Rick Givens
Planning Consultant
18680 Sunblaze Dr.
Oregon City, Oregon 97045

SUBJECT: SUB-16-01, et al, at 1270 Rosemont Road

We have revised our application materials to address the items raised in your letter of incompleteness dated May 4, 2015. Specifically, the following changes and corrections have been made:

Planned Unit Development Subdivision Application

Figure 5: Aerial Photograph – Google Earth 2015 Rosemont Road Property S&A 2409

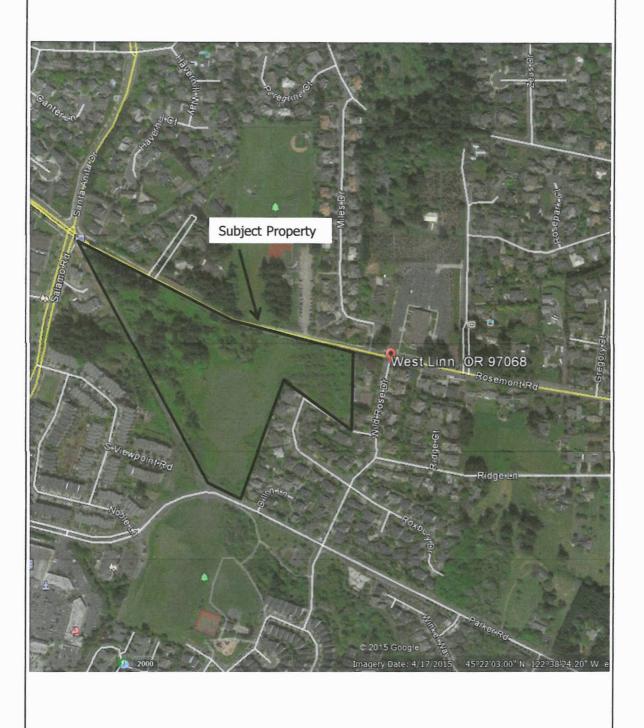
32.000: Please map and discuss the western ephemeral stream that originates on Rosemont Road at a storm water pipe outfall.

Discuss the ephemeral stream outfall into the WRA and proposed means of dissipating the flow. Please provide the five appendices referred to on page nine (final page) of the Schott and Associates report.

Action: A letter dated May 23, 2016 from Schott and Associates is attached. It states that there is no western ephemeral stream on the property. The previous report from Schott and Associates noted that there is also no eastern ephemeral stream. There are to culverts that pass under Rosemont Road and drain onto the property, but the flow is not channelized. It is proposed that the water from these two drainages be directed to manmade channels, as shown on the site plan, in accordance with City policy on ephemeral streams. The flows are minimal and the water will continue to be direct to the Tanner Creek Water Resource Area. Riprap will be installed at the outfalls into the Water Resource Area to dissipate energy from the flows and ensure that there will be no erosion associated with the drainages.

Plan. The vicinity map, aerial photo, and Existing Conditions maps are attached to this letter. The Development Plan is a reference to the Tentative Plan, which is being re-submitted. The Delineation Plan is now labeled "Wetlands Plan" and is included as Sheet 5 of 5 of my plan set. Reduced copies of these two plans are enclosed to be included with the Natural Resources Assessment report.
